**TOWN OF HERNDON, VIRGINIA
ARCHITECTURAL REVIEW BOARD
VIRTUAL PUBLIC HEARING AGENDA
DECEMBER 16, 2020
HERNDON COUNCIL CHAMBERS BUILDING
765 LYNN STREET
7:30 P.M.**

Subject: ARB #20-026, 365 Elden Street, Outback Steakhouse New Construction Update

**Re: ARB Application for Freestanding Sign Permit, ARB #20-028
Elden Street Marketplace, 1025 Herndon Parkway, Herndon, VA 20170**

**Re: ARB Application for Wall Sign Permit, ARB #20-029
Elden Street Marketplace, 1025 Herndon Parkway, Herndon, VA 20170**

PROPOSED RENDERINGS

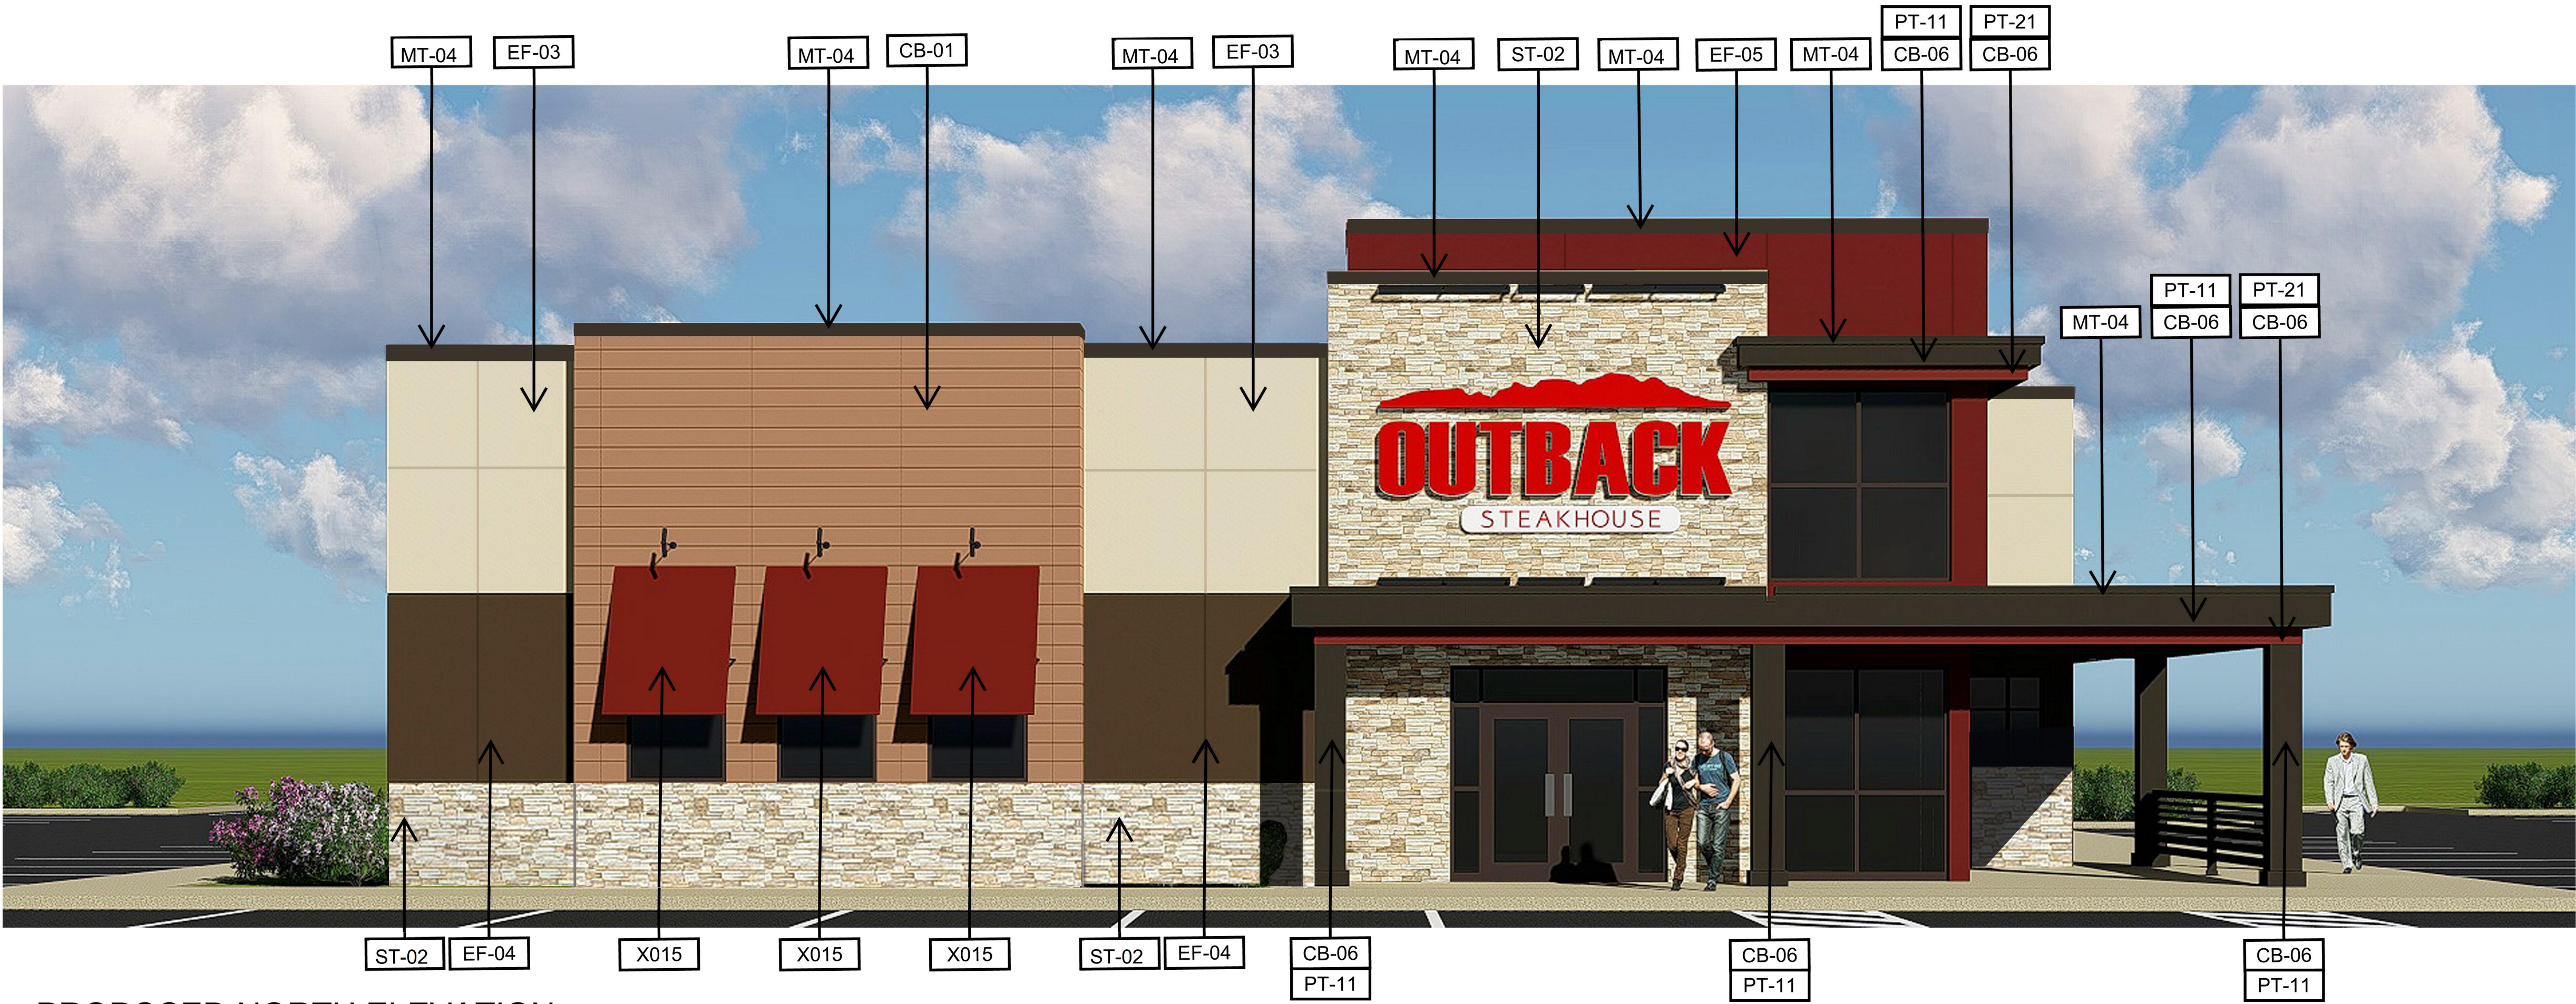
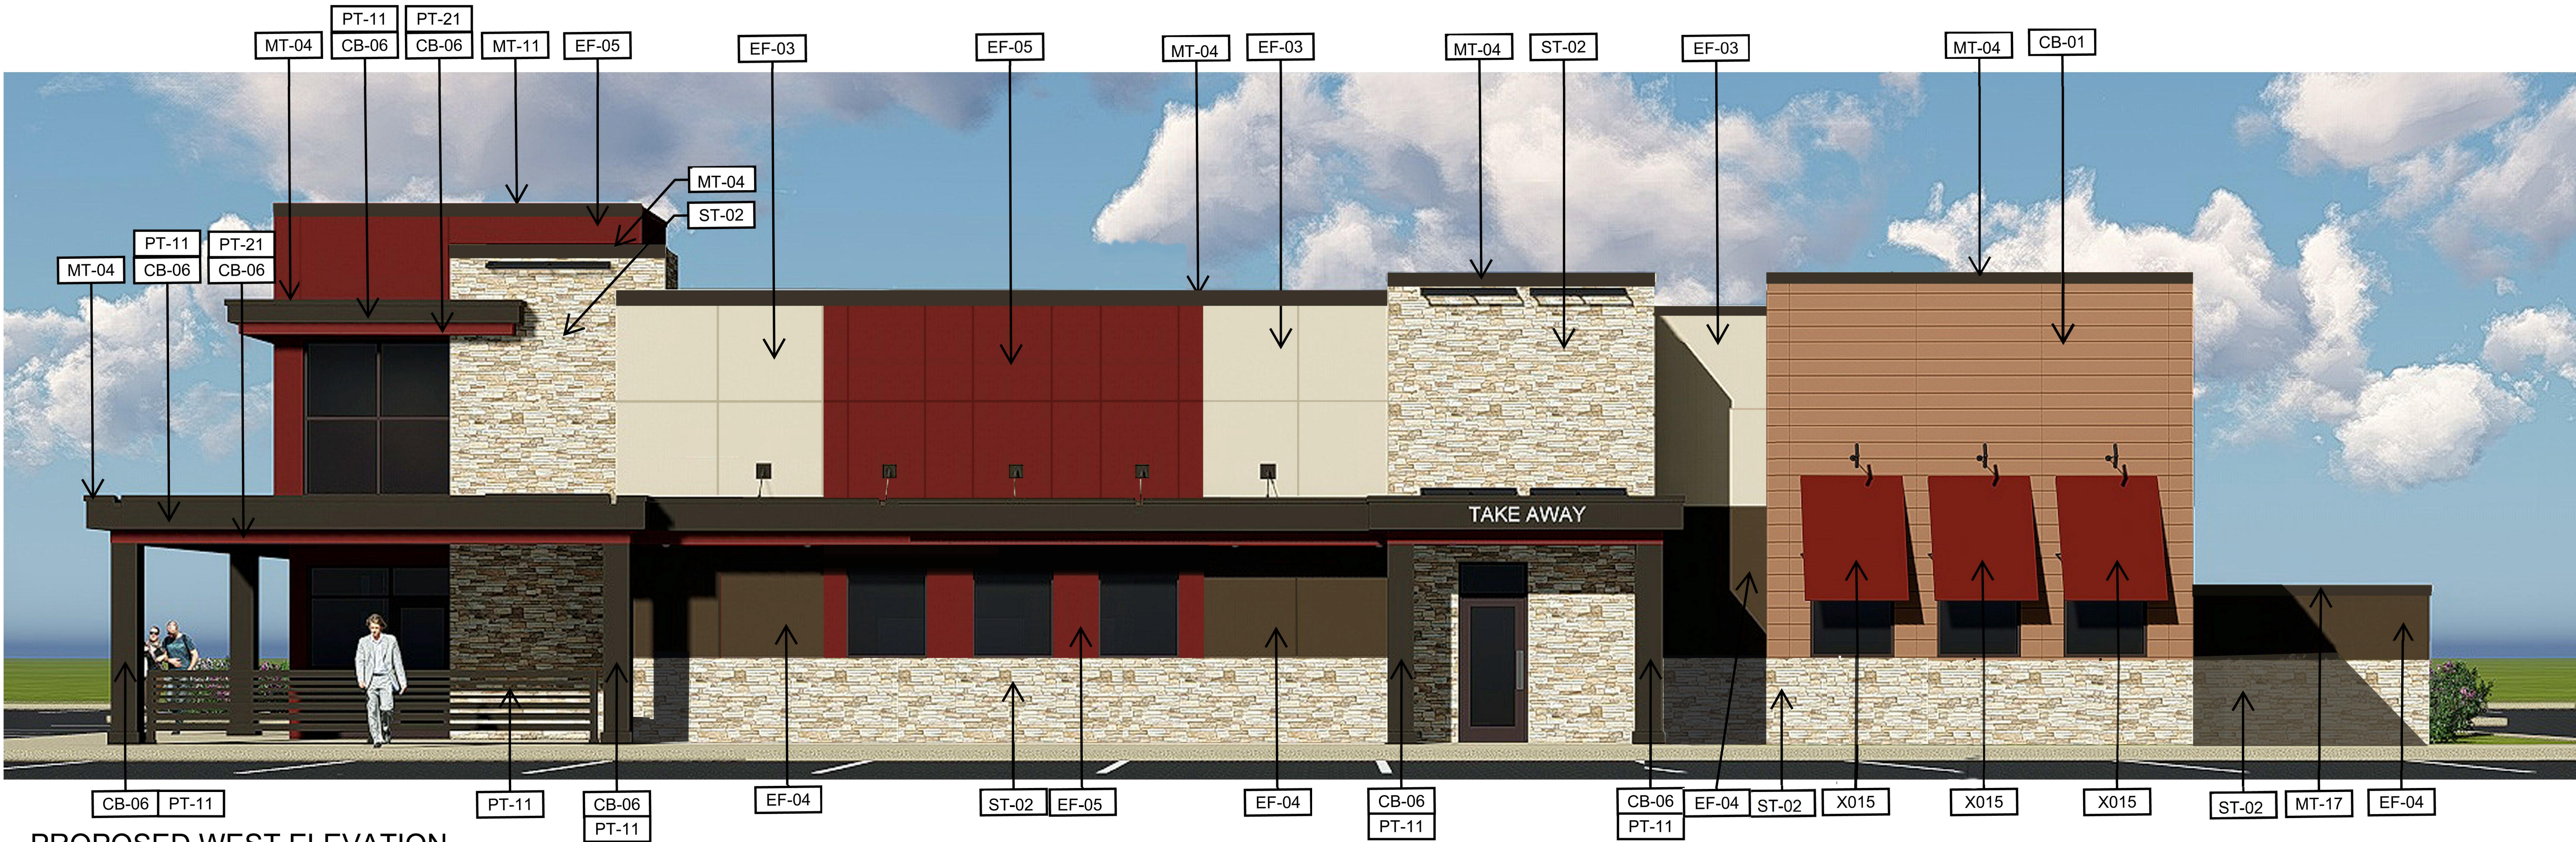
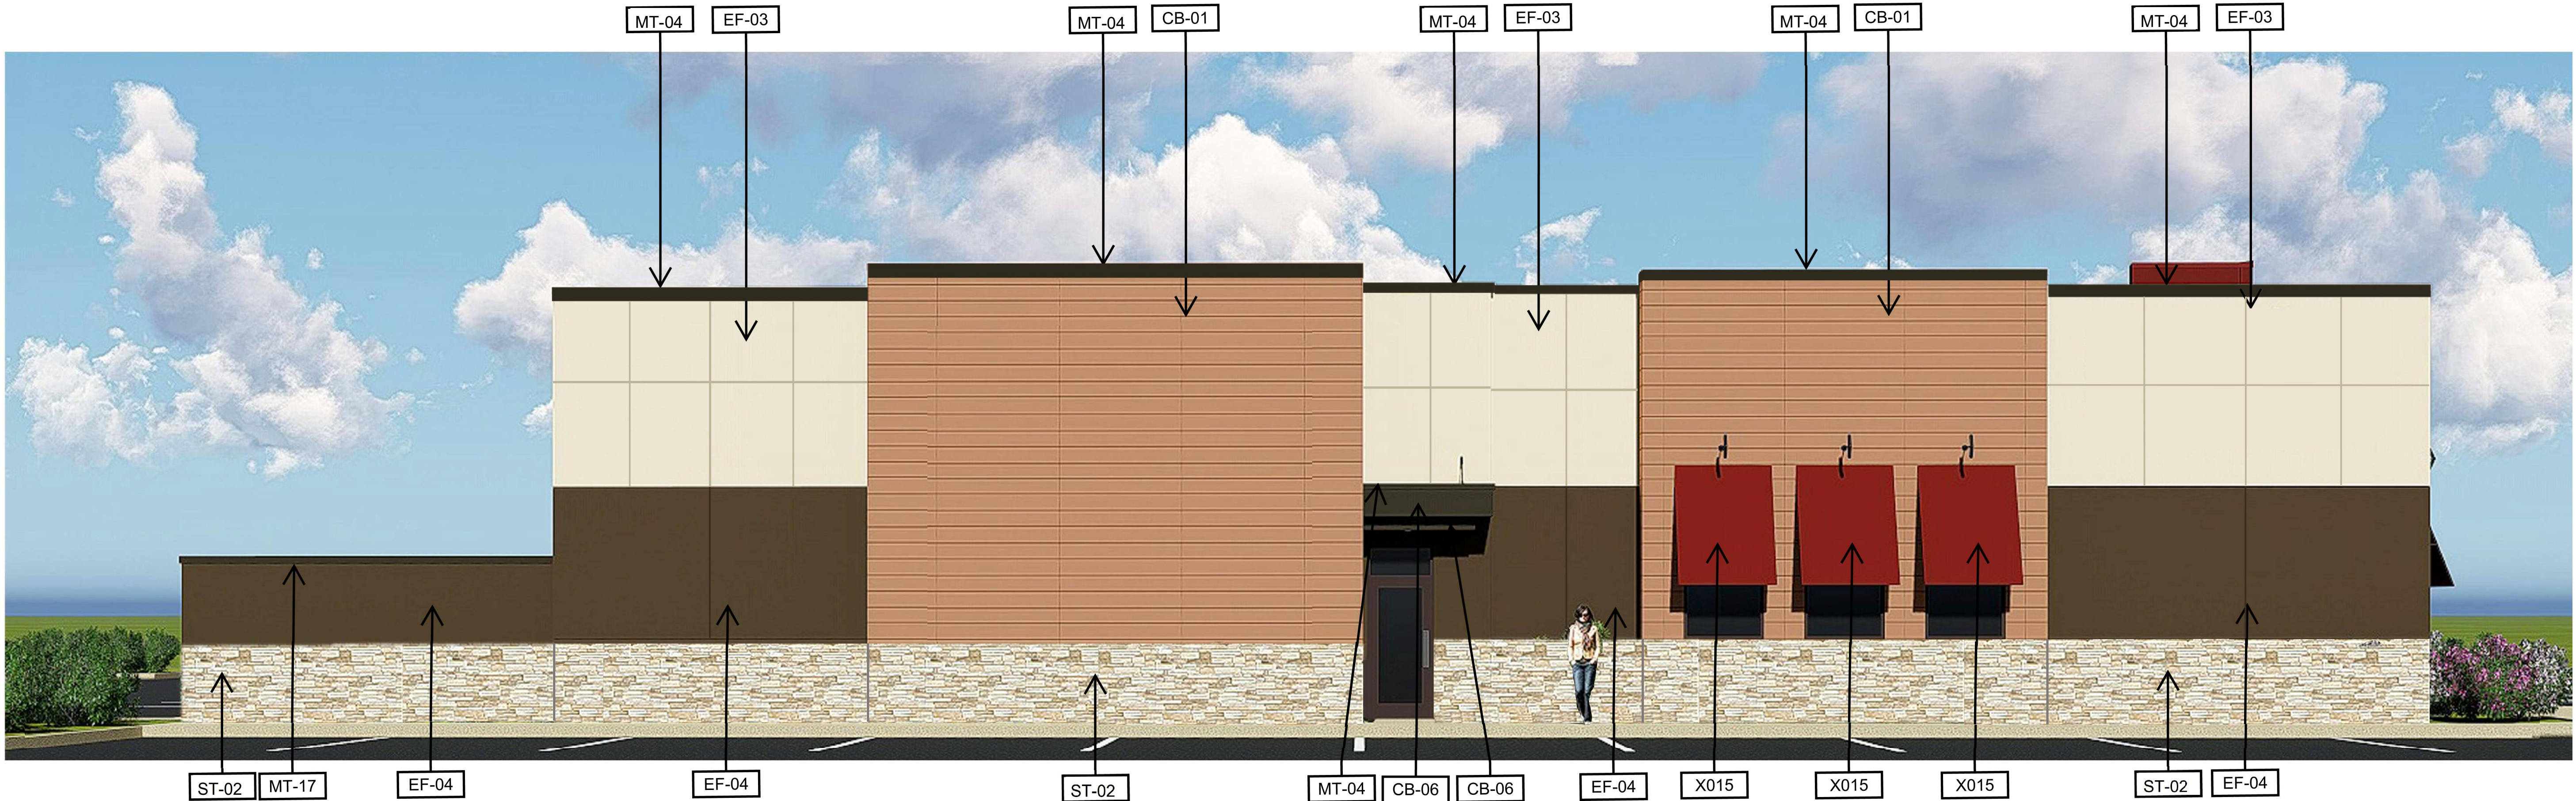
There were no updates requested of the applicant by the Board at the December 2, 2020 ARB Work Session. However, one Board member agreed with staff recommendation for addressing the extensive use of EIFS on the building exterior. Since the work session staff has received revised elevation drawings from the applicant in which scoring of the EIFS surfaces is used to break of the extensive sections of this materials and create the appearance of a panelized wall system (Attachment #1). While this simple design detail is somewhat superficial, the revision addresses the staff concerns and recommendation for breaking expanses of EIFS on this commercial building. Staff finds this design detail will be in keeping with the building's corporate image, and effectively create visual interest while not over-complicating the composition of exterior materials.

- 1. The new commercial building and associated site features shall be constructed and installed in substantial conformance with the original application and design materials submitted on November 5, 2020 and updated building elevations submitted on December 9, 2020.**

SIDE 1 ELEVATION
1/4" = 1'-0"

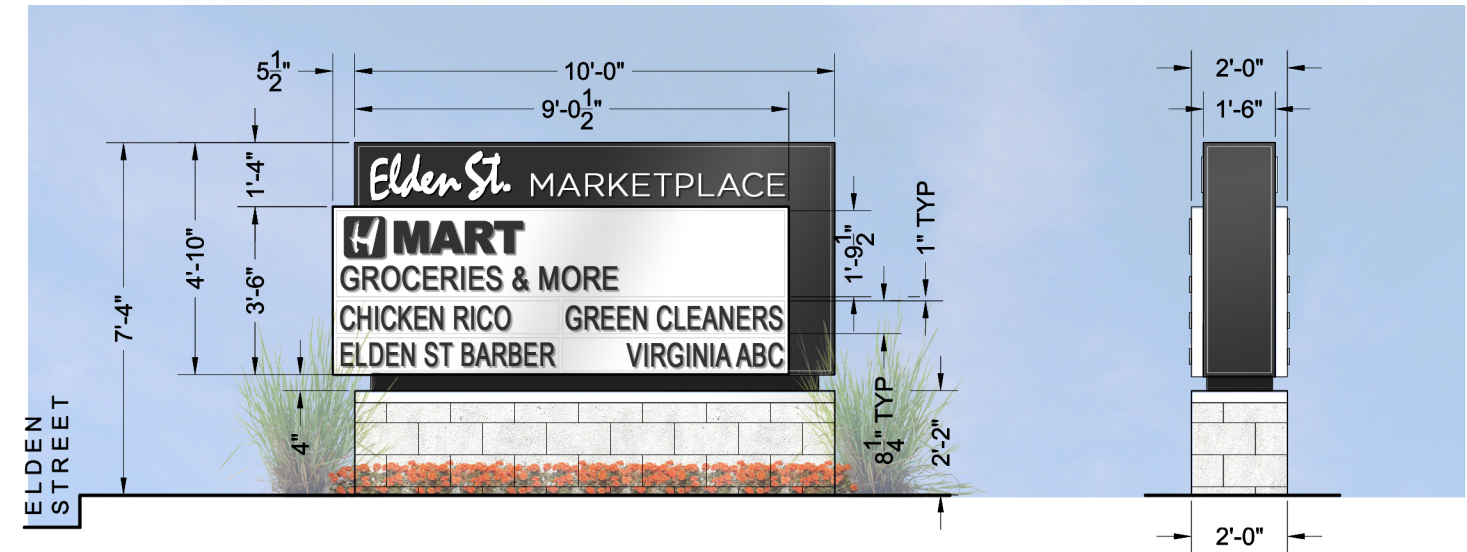
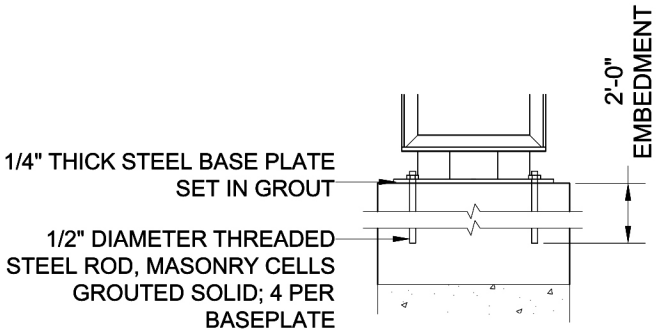
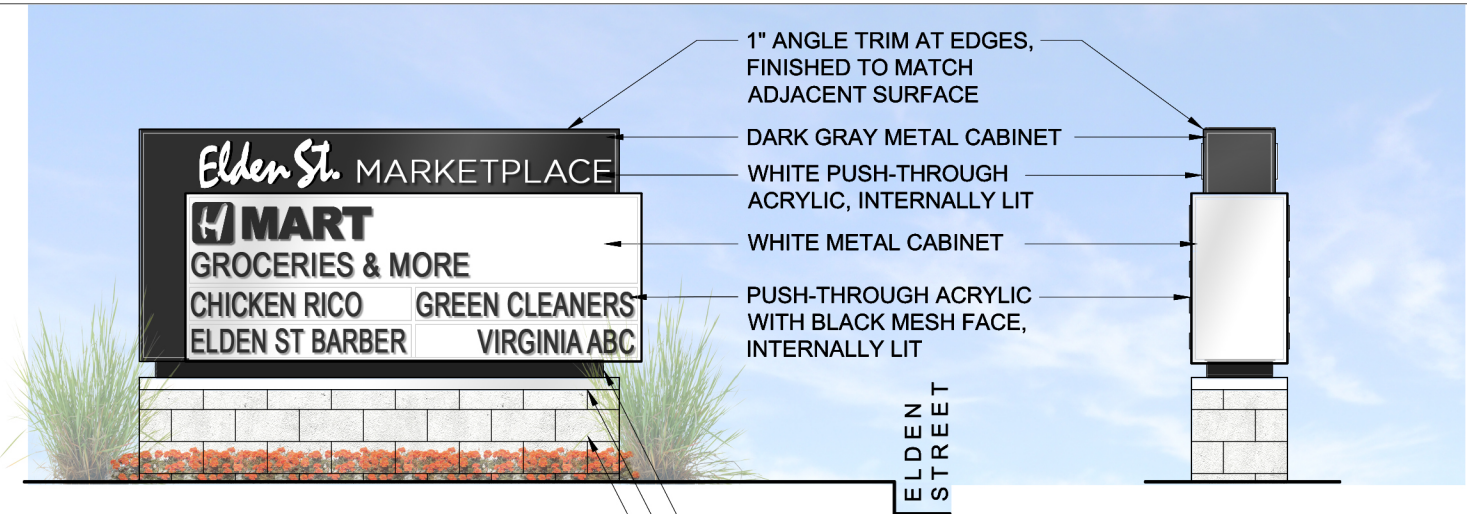
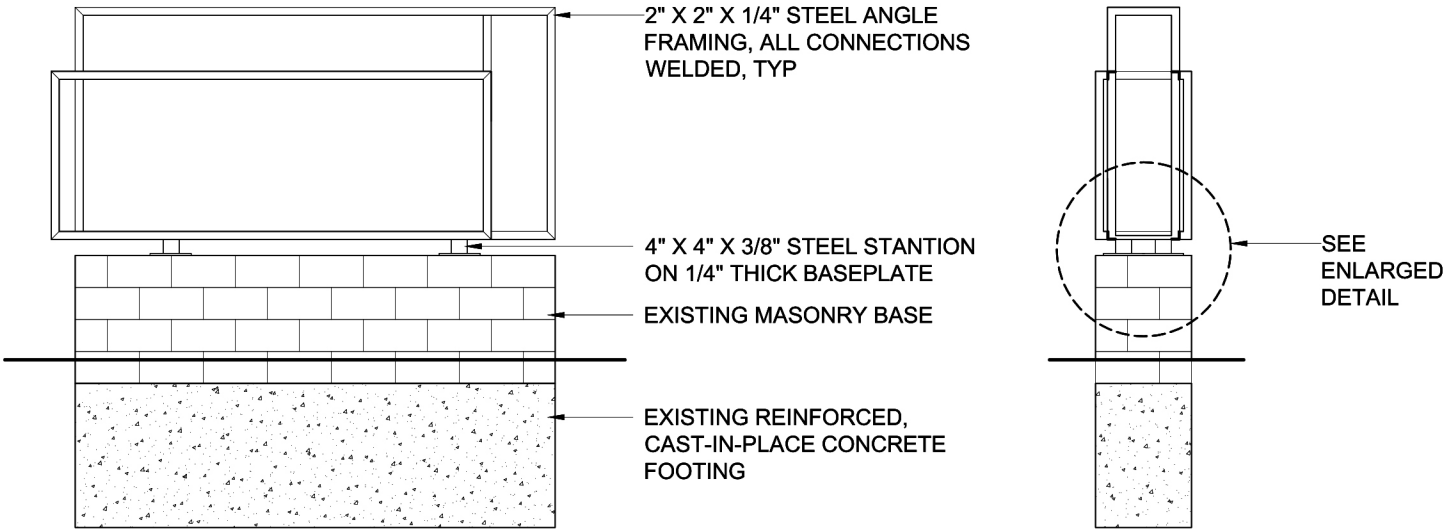
“...the sign does contain some text/lettering that is less than 6” in height and will need revision to comply with the Town’s Zoning Ordinance Section 78-141.4.”

The enclosed submission has adjusted the letter height to comply with the zoning minimum. The tenant sign panel dimensions have been adjusted accordingly to accommodate the corrected text height. The overall sign face area remains unchanged and compliant.
